Mecklenburg County
Health Department

Re: Application for improvement permit for Eveline M. Hodge
Property Site: 11817 Brief Road
Health Department file no. 11937

SOIL/SITE EVALUATION
for ON-SITE WASTEWATER SYSTEM

PROPOSED PLOT PLAN

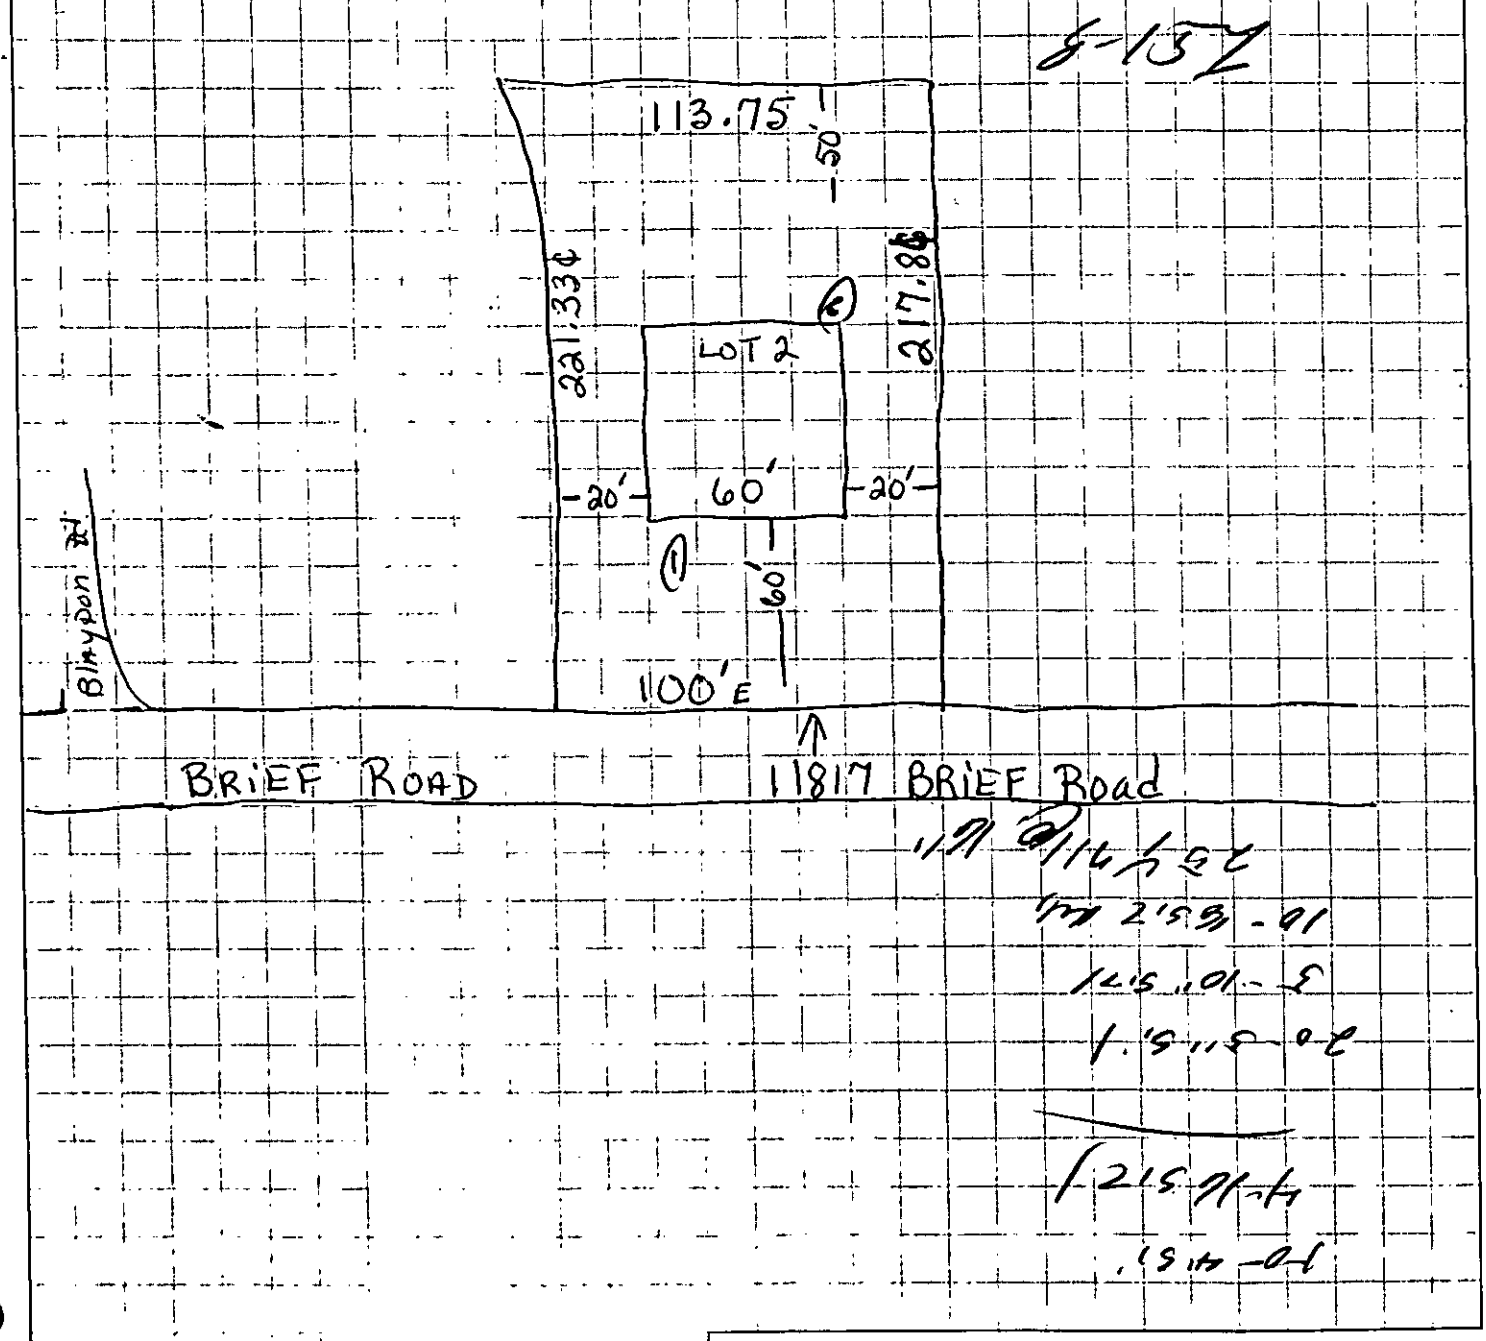
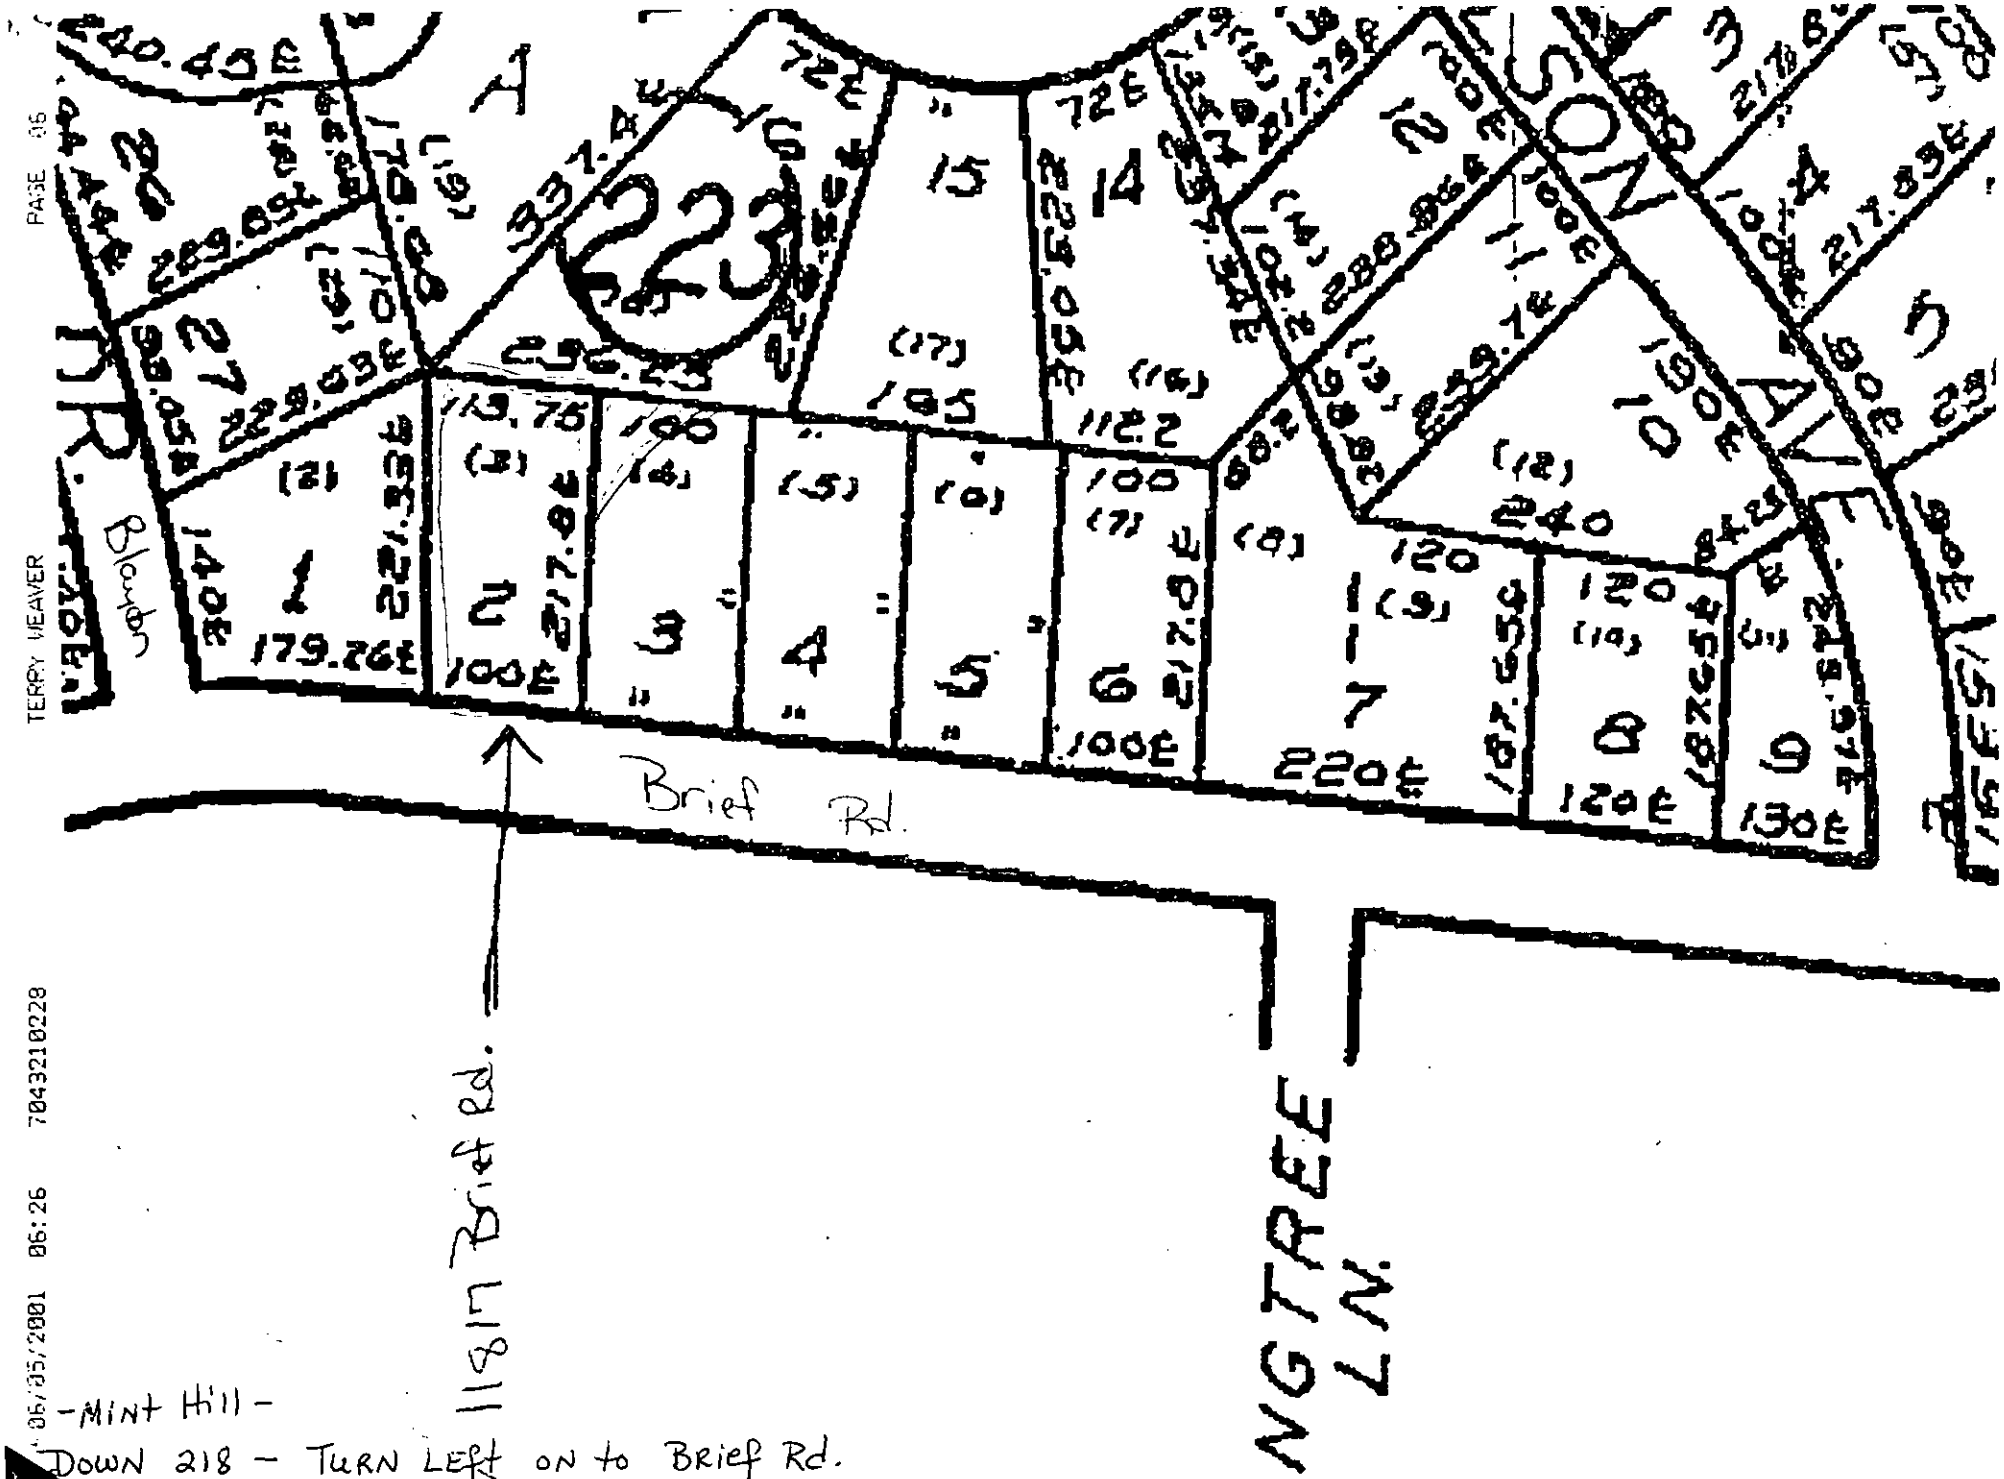
Based on the criteria set out in Title 15A, Subchapter 18A, of the North Carolina Administrative Code, Rules .1940 through .1948, the evaluation indicated that the site is **UNSUITABLE for** a ground absorption sewage system. Therefore, your request for an improvement permit is **DENIED.** A copy of the site evaluation is enclosed. The site is unsuitable based on the following:

_____Unsuitable soil topography and/or landscape position (Rule .1940)
___X___Unsuitable soil characteristics (structure or clay mineralogy) (Rule .1941)
___X___Unsuitable soil wetness condition (Rule .1942)
___X___Unsuitable soil depth (Rule .1943)
_____Presence of restrictive horizon (Rule .1944)
___X___Insufficient space for septic system and repair area (Rule .1945)
_____Unsuitable for meeting required setbacks (Rule .1950)
_____Other (Rule .1946)

However, the site classified as **UNSUITABLE** may be classified as **PROVISIONALLY SUITABLE** if written documentation is provided that meets the requirements of Rule .1948(d). A copy of this rule is enclosed. You may hire a consultant to assist you if you wish to try to develop a plan under which your site could be reclassified as **PROVISIONALLY SUITABLE.**

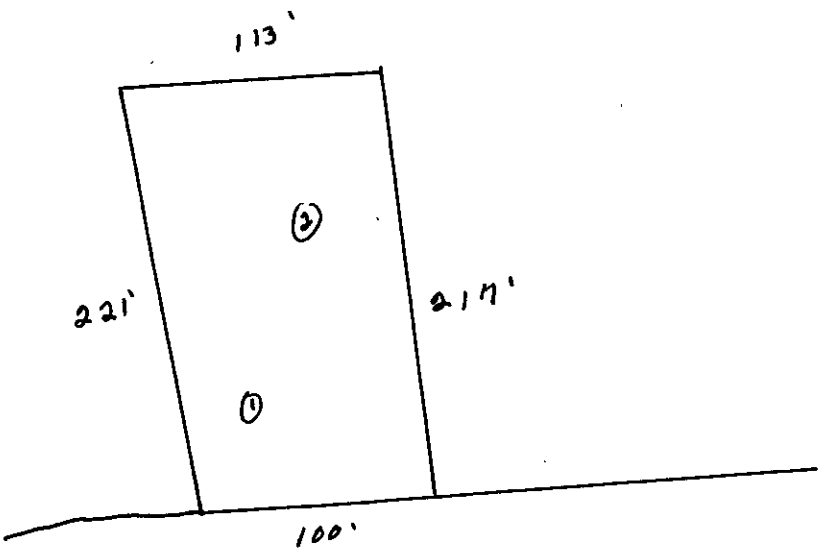
PROFILE #	.1940 Landscape Position/ Slope%	Horizon Depth (IN.)	SOIL MORPHOLOGY .1941 Structure/ Texture	SOIL MORPHOLOGY .1941 Consistence Mineralogy	OTHER PROFILE FACTORS .1942 Soil Wetness/ Color	.1943 Soil Depth (IN.)	.1956 Sapro Class	.1944 Restr Horiz	Profile Class & LTAR
	6-15								
1	LS	0-4	GR/SIL	FR/SEXP/NS/NP	>16" TO SOIL WETNESS	16	N/A	NONE	US
		4-16	WKSBK/SICL	FR/SEXP/SS/SP					
2	LS	0-5	GR/SIL	FR/SEXP/NS/NP	2.5Y7/1@ 16".	18	"	"	US
		5-10	WKSBK/SICL	FR/SEXP/SS/SP					
		10-18	ABK/SIC	VF/EXP/VS/VP

Other Factors (.1946): _____
Site Classification (.1948): UNSUITABLE
Evaluated By: W.R. Marlin, LSS, 8/24/01 W.R. Marlin
Others Present:

COMMENTS 100% Repair not required, site previously investigated 1977
